# FMB130 Product Change Notifications

[Main Page](#) > [Advanced Trackers](#) > [FMB130](#) > **FMB130 Product Change Notifications**

## 2021.04.30: Bluetooth® Improvement

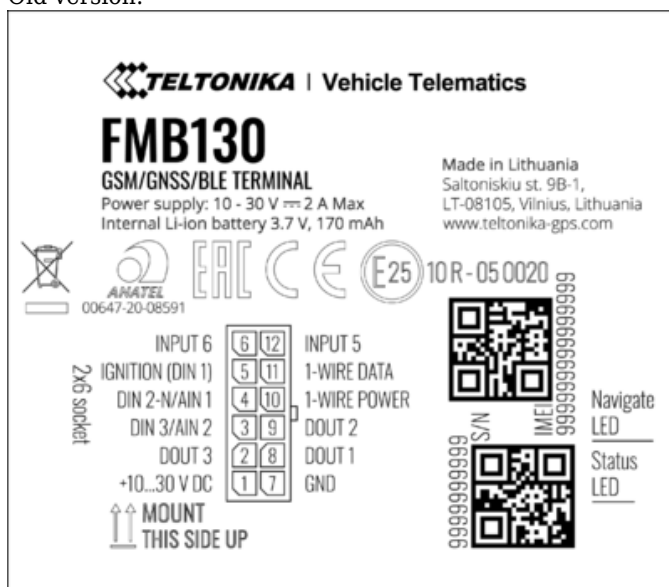
Change type	Internal	
Detailed description	Bluetooth® antennas are improved for FMB130 device ensuring better signal strength. The efficiency of Bluetooth® antennas is considerably increased when receiving or transferring data.	
Change reasons	Following the changes, the capabilities of our devices will be greatly improved to provide better performance when Bluetooth® signal is obstructed or longer distance coverage is required	
Product release date	October 2021
